Subject: RE: 22/1032/CR - Husum Way

The applicant would like to start development today and they still have a number of conditions outstanding, could you please let me know if you are happy for me to discharge the following conditions.

I can now provide you with an update on your application.

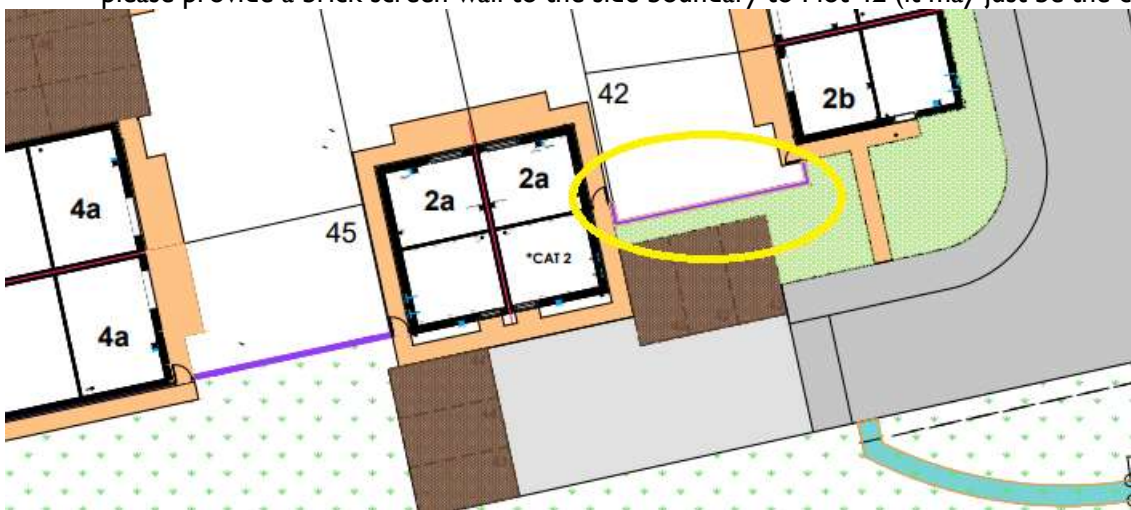
- **Condition 5 – Discharged** – Block paving plan is acceptable.
- **Condition 8 – Condition not discharged** - On Drawing No. 2207-02 P8 can I ask that the recreational footpath is moved away from the driveway/parking spaces to Plot 21, as shown below.
